ADDENDUM NUMBER 1

Project Number 70142206

Project Title Independence and Benton Boulevard Intersection
Federal Project No. STP 3434 (402) and TIP No. 611169

ISSUE DATE: January 28, 2016

5 BRONZE ACCESS PANEL - DETAILS
SCALE: NTS

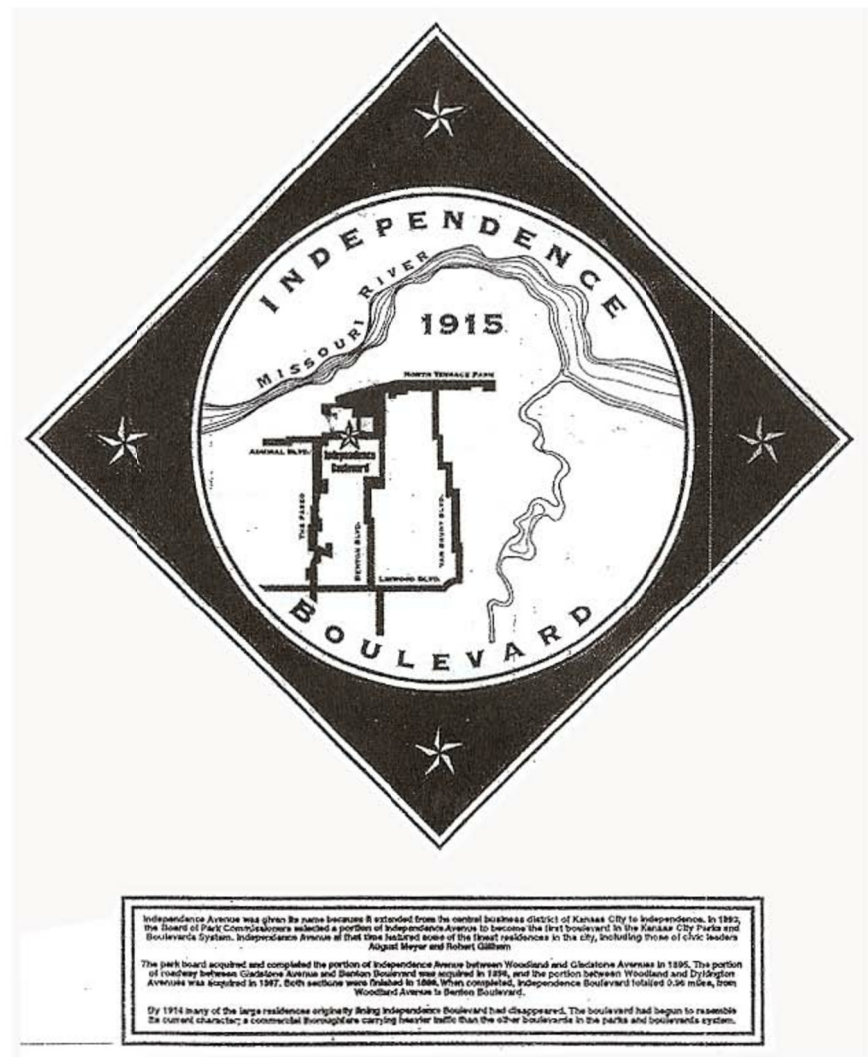
- b. Added Detail 5 – Bronze Access Panel - Details, add two new details showing the maintenance access panel to be located at the top of each marker. The maintenance access panel is subsidiary to the bid item "Boulevard Marker". **Refer to attached sheet 58, reissued in its entirety.**

Sheet No. L204

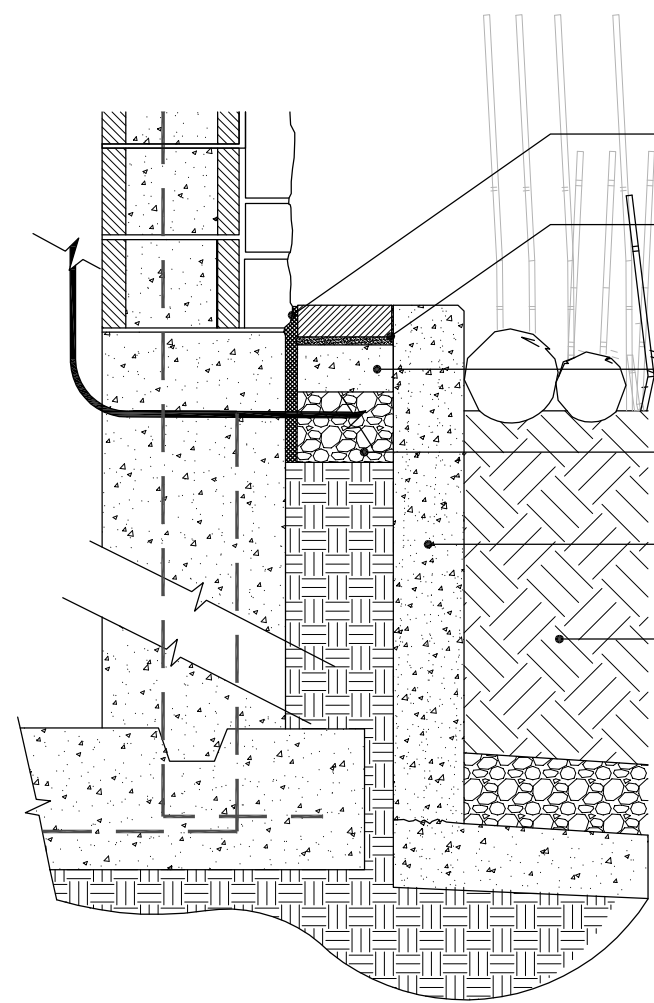
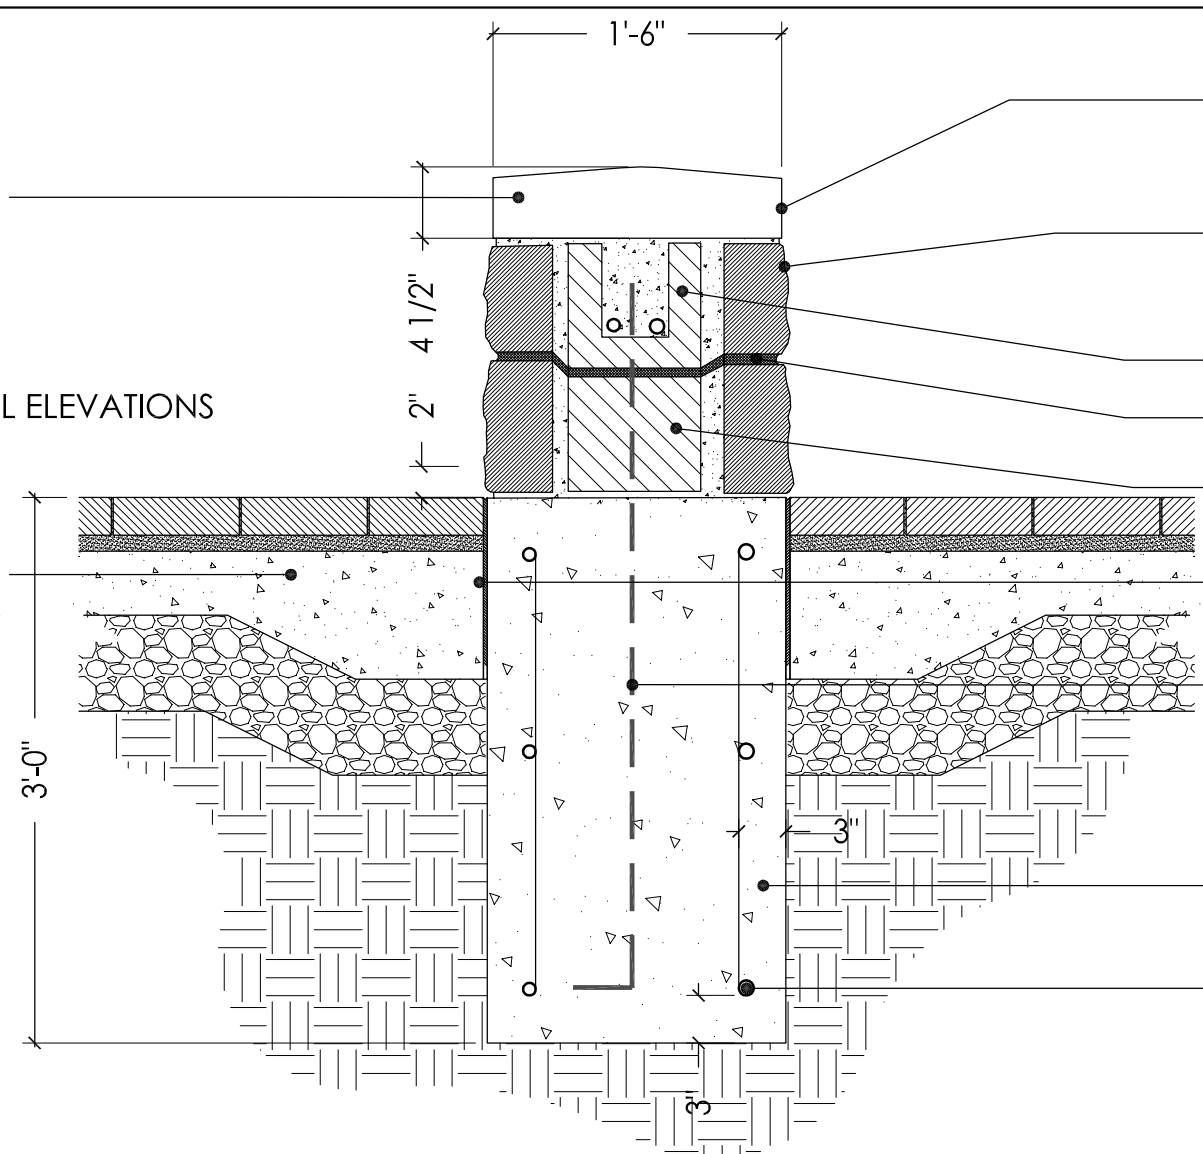
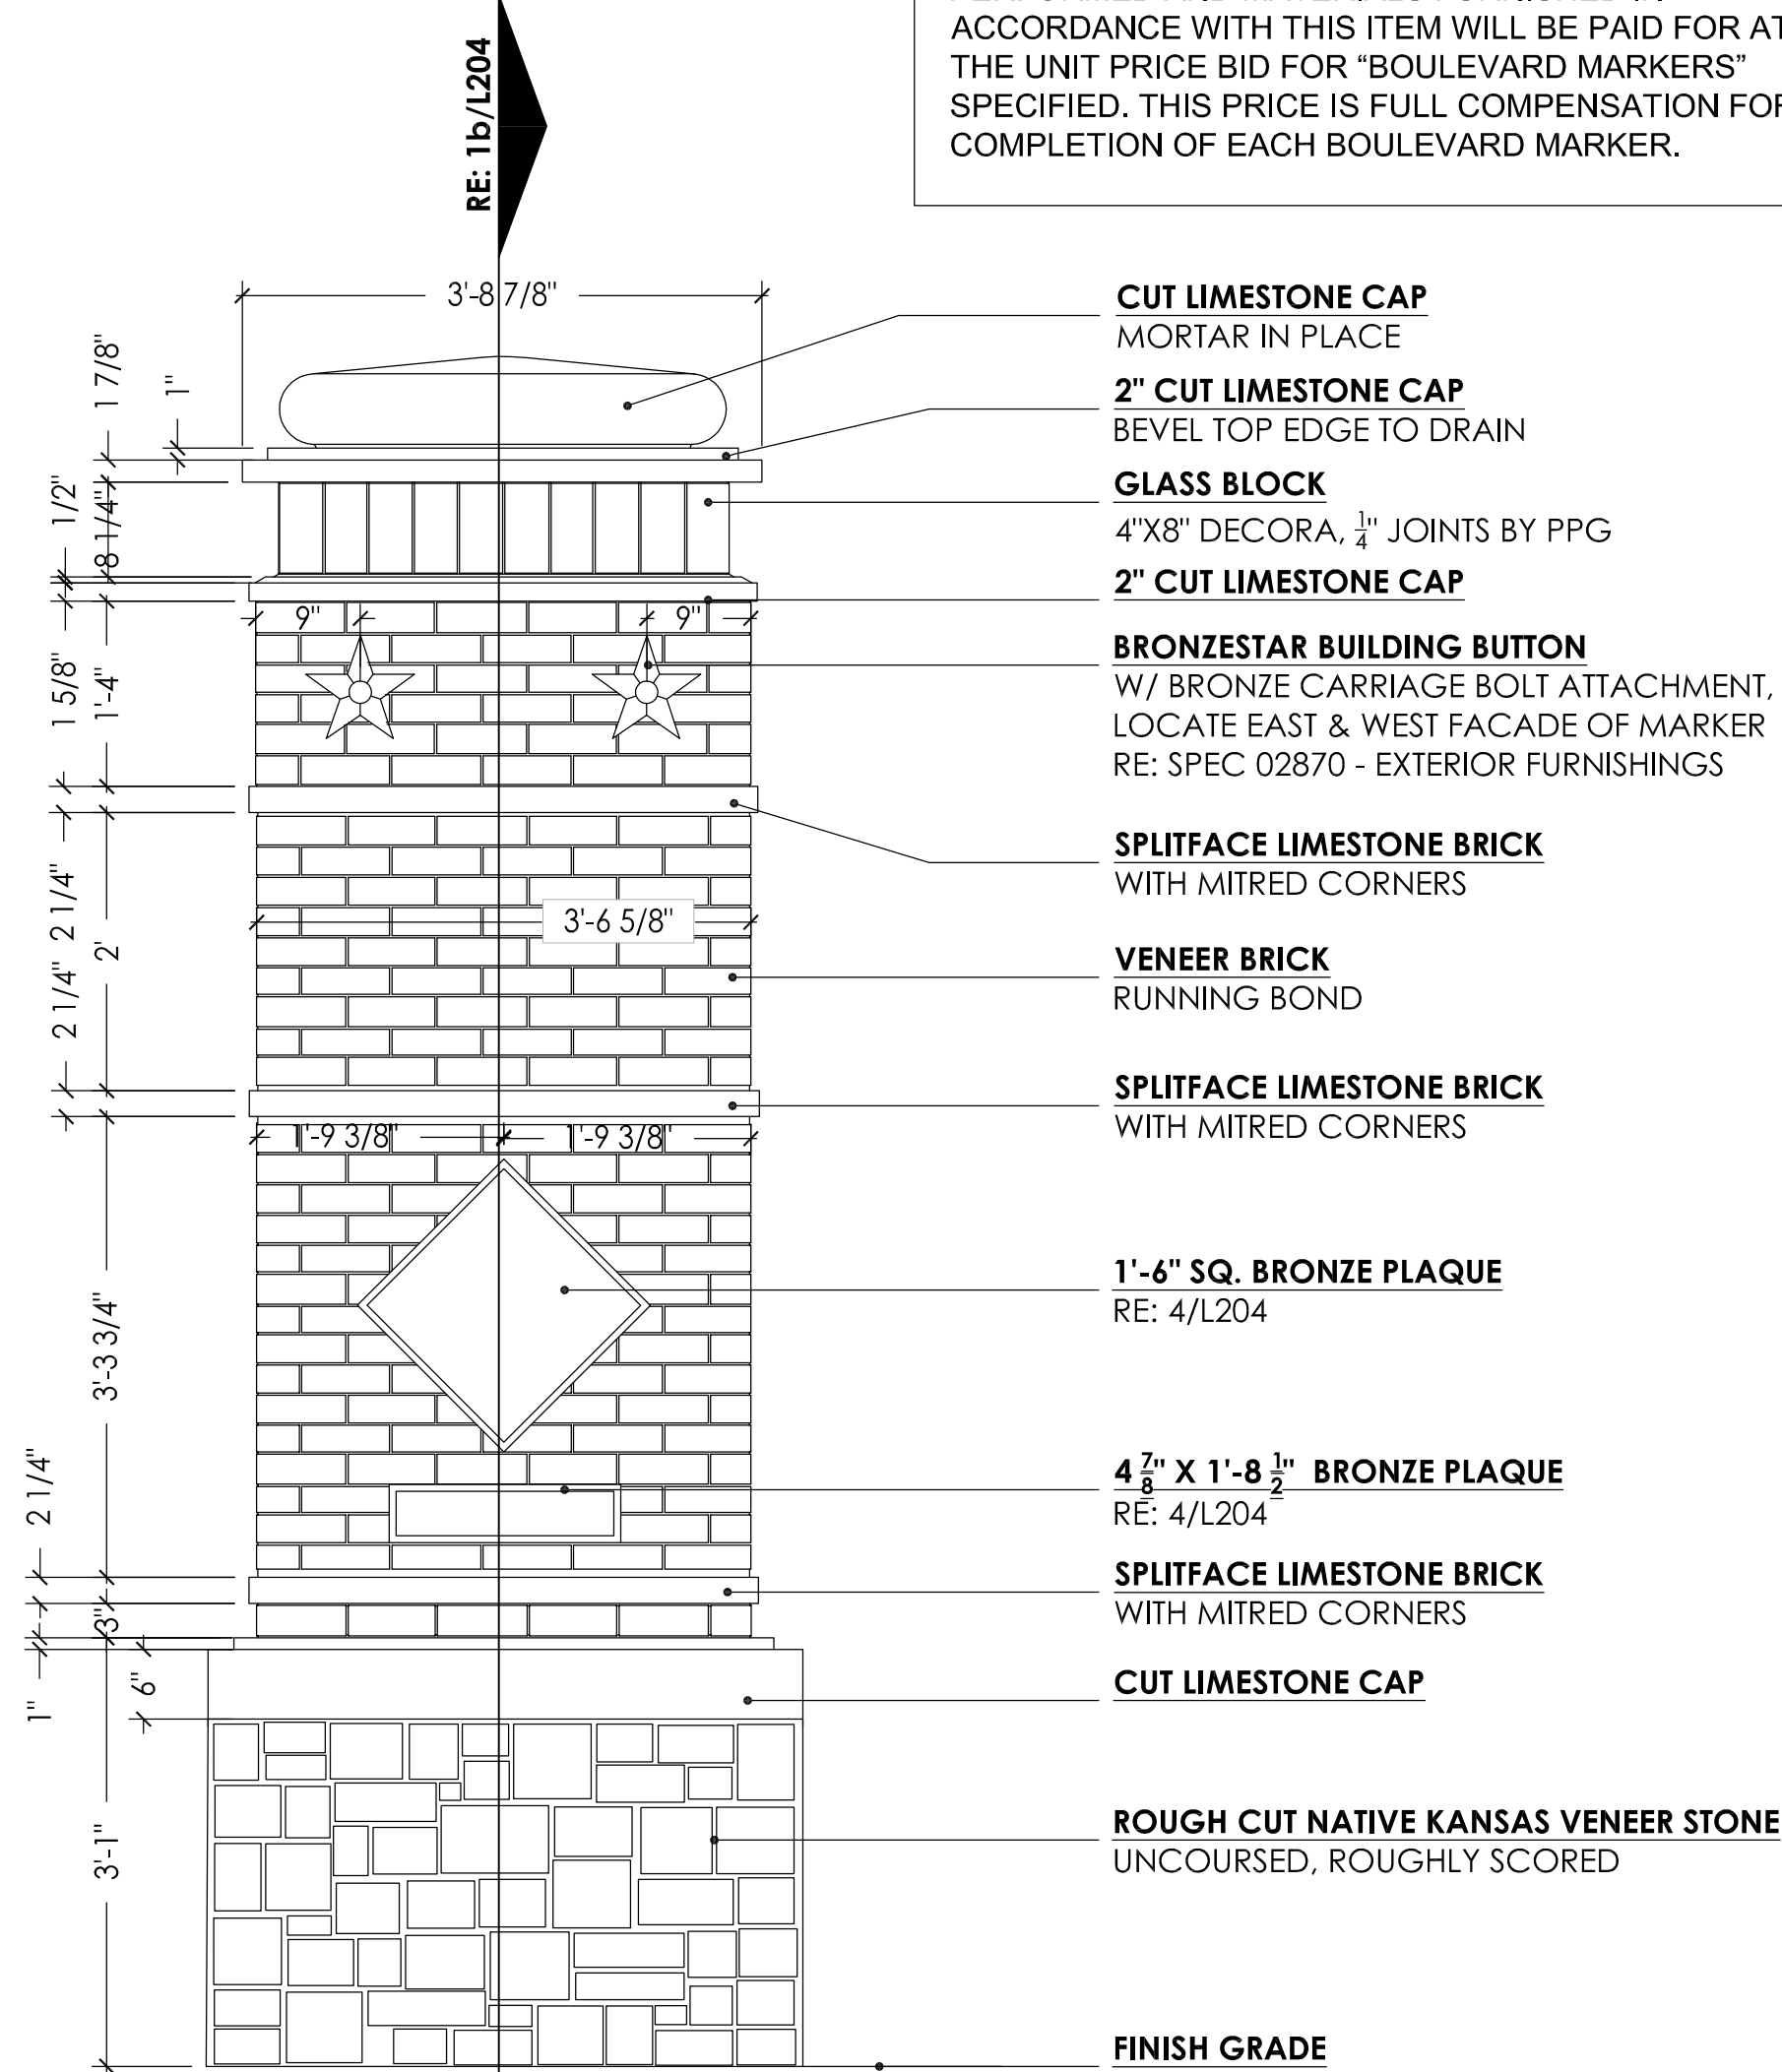
5. Modify Sheet No. 58 (L204) as follows:
 - a. On the Detail 4 – Boulevard Access Panel, clarify as follows: This is a detail for the Bronze Plaque(s) and not the access panel. New details have been provided as part of this addendum for the access panel. Official artwork will be provided to the selected contractor of the Bronze Plaque which will specify all wording to include in the plaque.

CITY OF KANSAS CITY, MISSOURI INDEPENDENCE BLVD DESIGN		LOCHNER 903 East 104th Street, Kansas City, MO 64131-3451	File No. 1-27-16
SIDEWALK & RAMP DETAILS			
Detailed By: DLF	Drawn By: AFR	Sheet No. 10R	
Checked By: CMS	Scale: 1"=10'

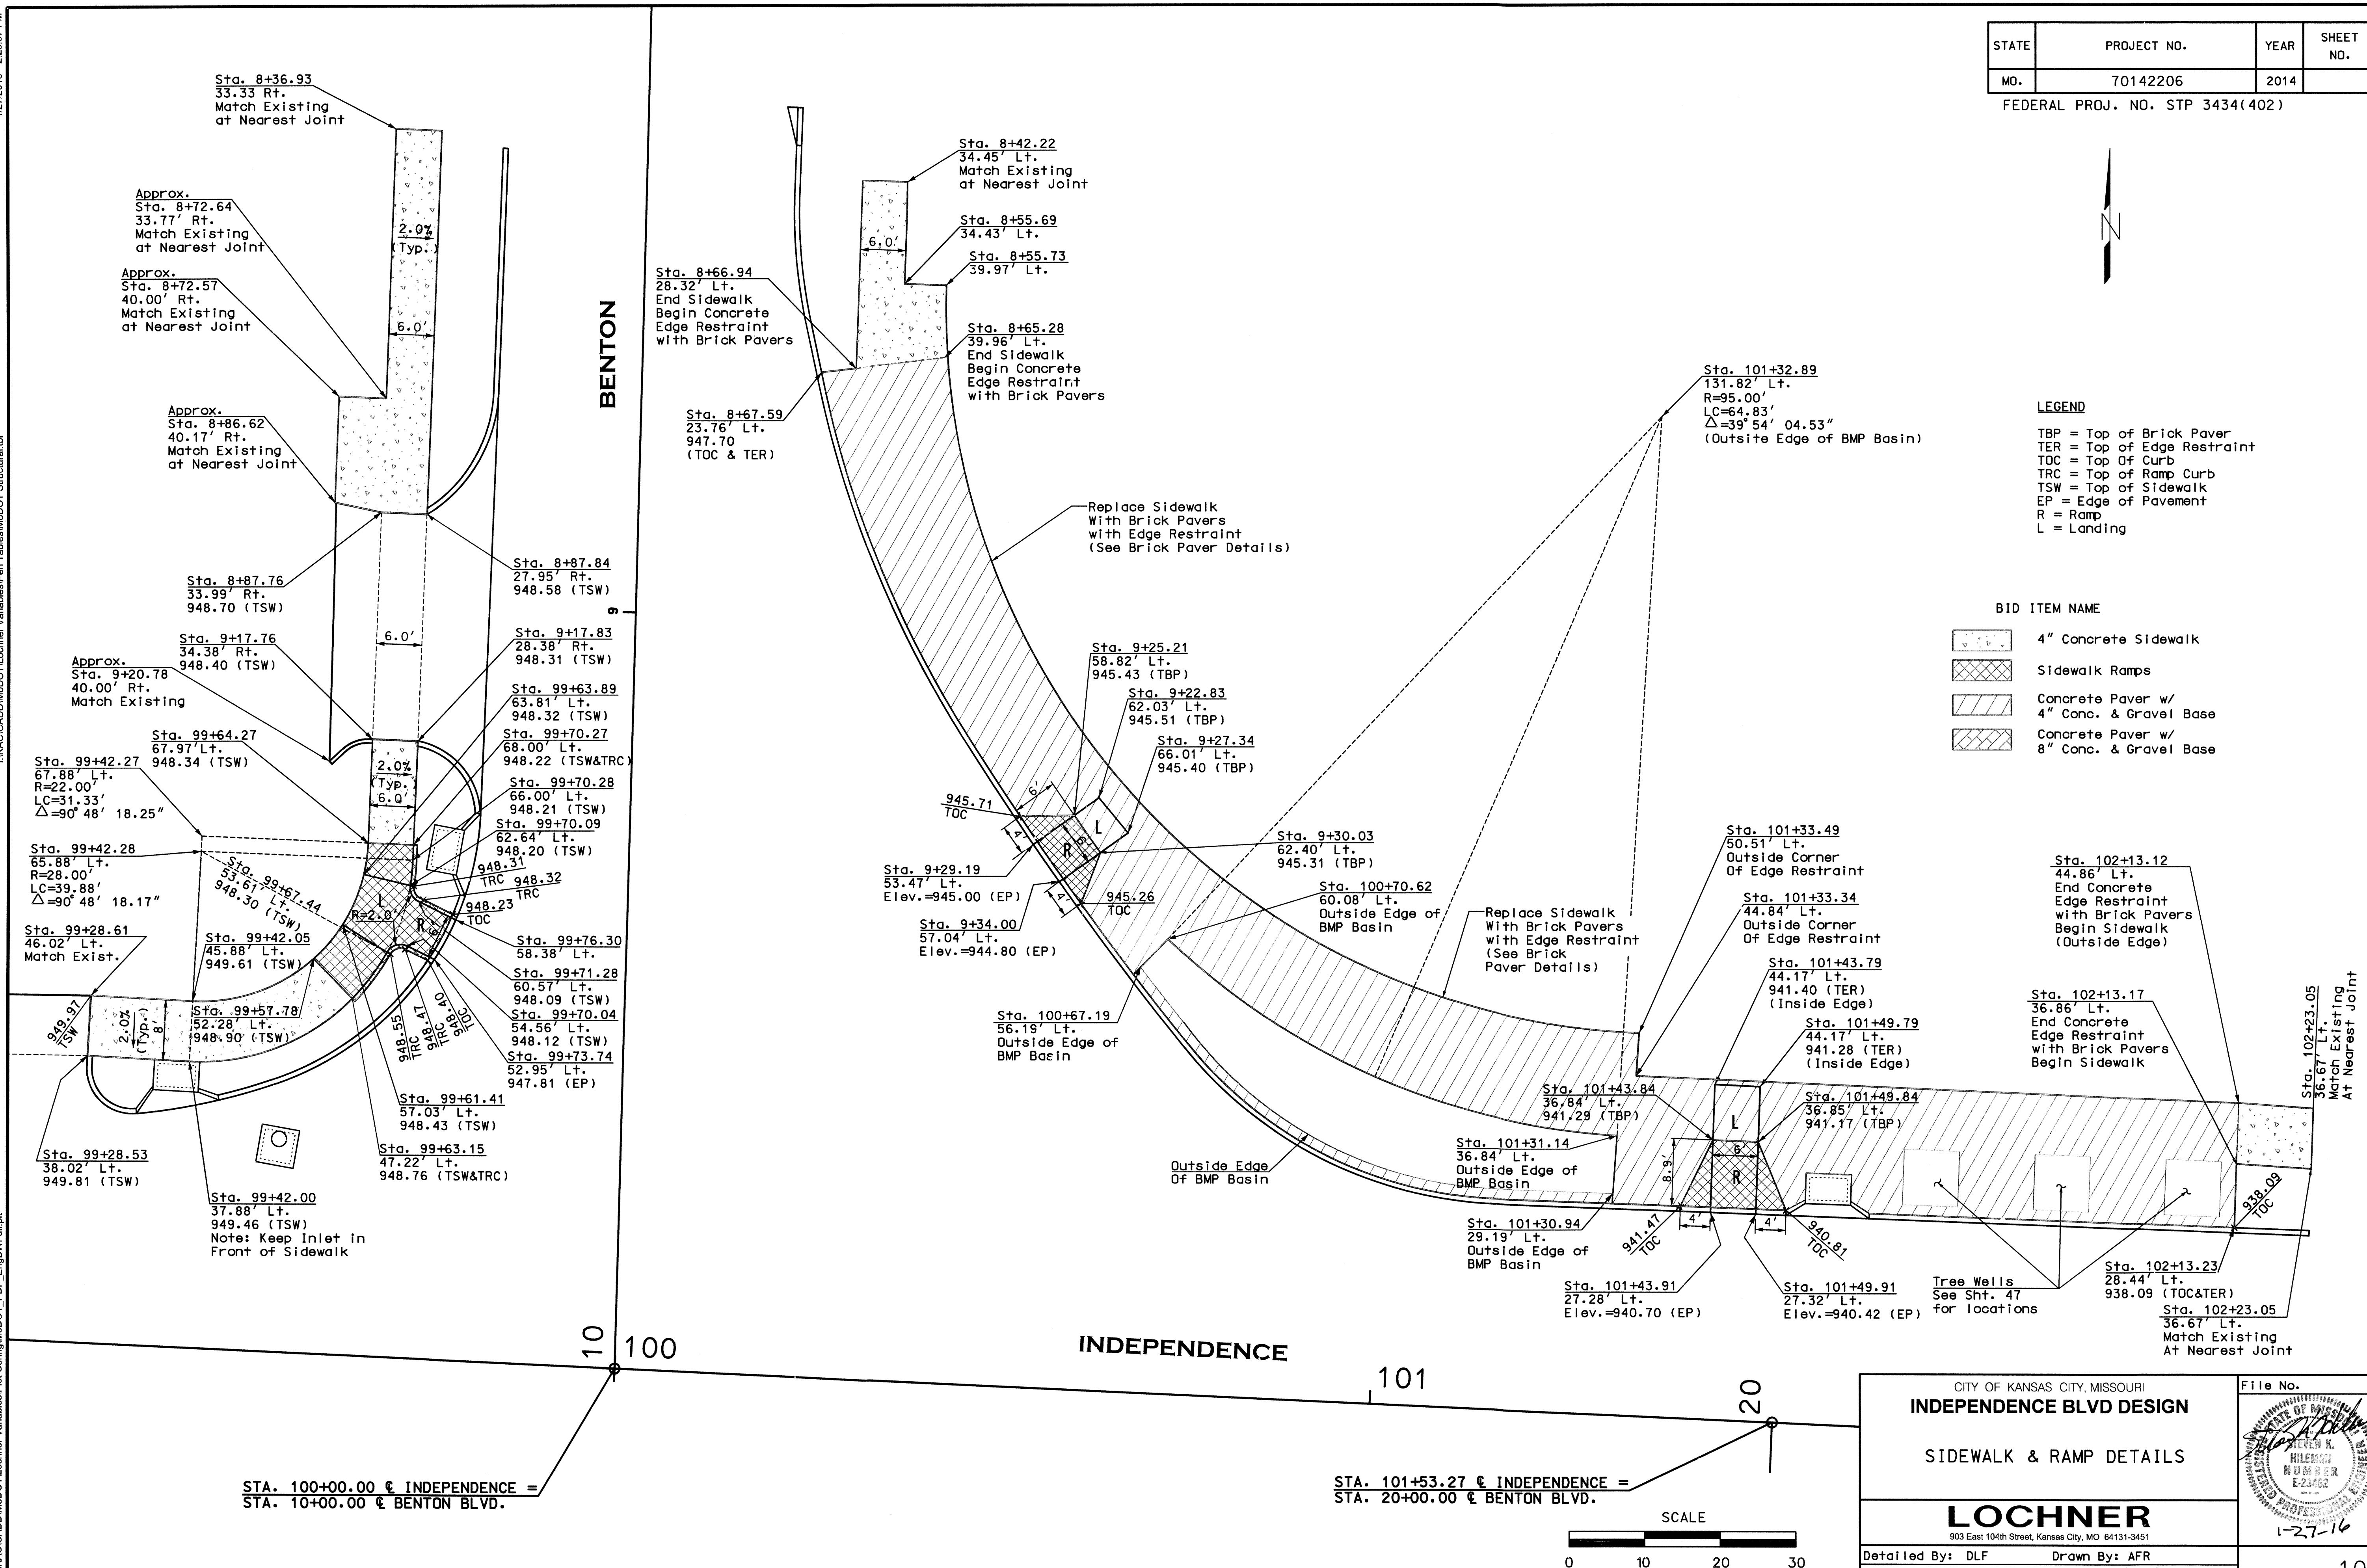
2. Modify Sheet No. 10 thru 13 as follows:
 - a. A legend and cross hatching have been added to these sheets to clarify the locations of the bid items for "4" Concrete Sidewalk", "Sidewalk Ramps" and "Concrete Paver w/ 4" and 8" concrete & gravel base" and to show that there is no overlap between these items. **Refer to attached sheets 10 thru 13, reissued in their entirety.**
3. Modify Sheet No. 55 (L201) – Independence and Benton Details as follows **(This sheet is not reissued with this addendum)**:
 - a. On the Detail 3 – Concrete Sidewalk in the lower left hand corner change the callout from "6x6, 1.4x1.4 WWF" to the following:
